NEANG Repair Fuel Cell Hangar B2600 Project

Questions & Answers #2

3 September 2026

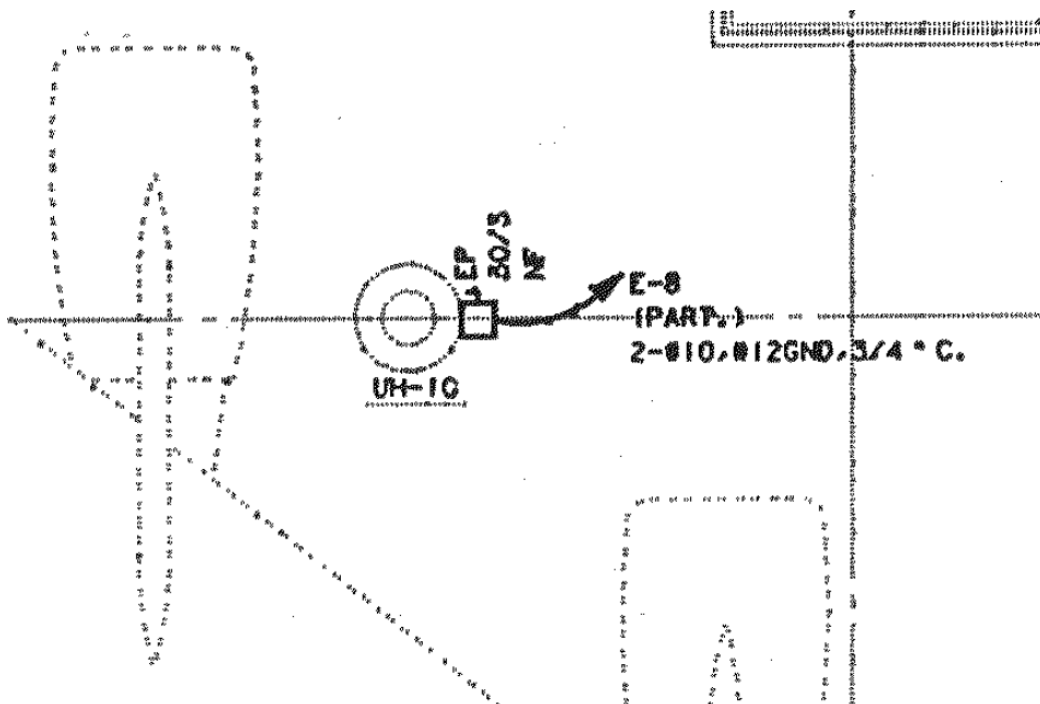
Question 2. Is there any information about the existing ground grid under the hangar slab we are supposed to connect the aircraft grounding receptacles to?

Answer 2. Original construction plans are available for review at the 155th Civil Engineer Squadron Building on the Air Base at the Lincoln Municipal Airport. Concrete slab varies in thickness but plans called for #5 @ 18" OC EW. See also the following detail.
